Crown Pastoral Land Tenure Review

ALLANDALE / GREENVALE

Public Submissions

**Allandale/Greendale Pastoral Lease
Submission on Preliminary Proposal for Tenure Review**

2 Recommended fence line on flats at Bushy Creek mouth, encompassing the wetland areas. Active restoration may be required (based on Google image).

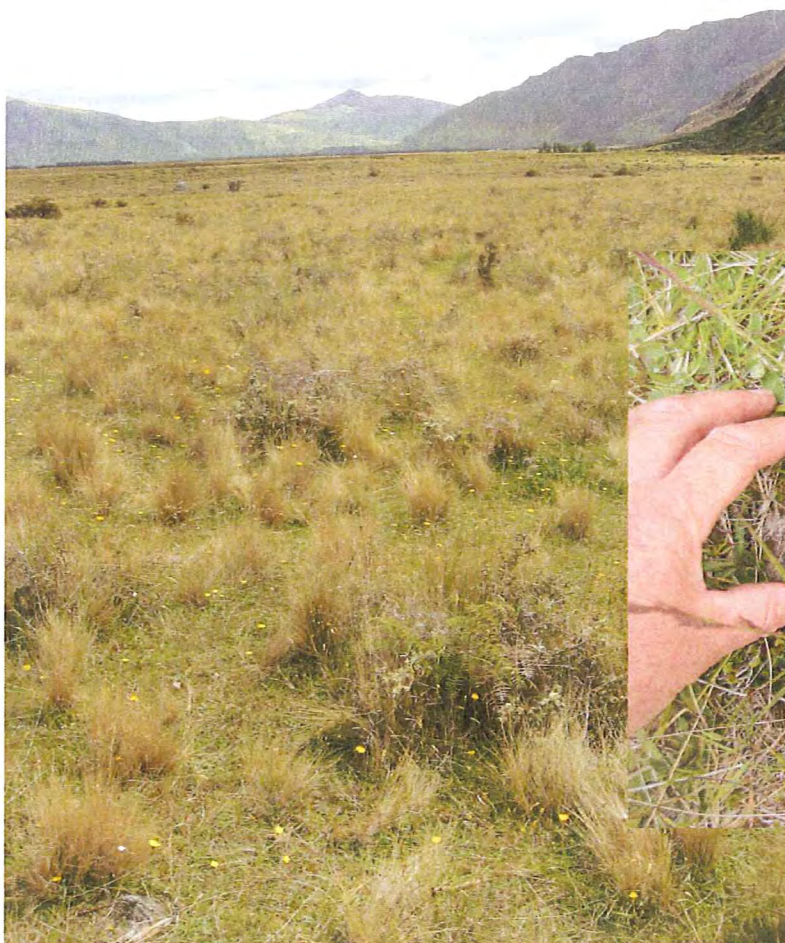
2 Rationale for thin dog leg of fencing between new fence A-B and the rectangle of wetland on the basin flood at G-H....it appears the map is too coarse and doesn't

accurately reflect the actual paddock/wetland layout here. I attach a google photo showing where it appears the fence should go in order to adequately encompass the wetland areas. There is a thin pale coloured area that also looks like a cultivated paddock within this area, not sure it worth including or not, may be impractical to exclude it.
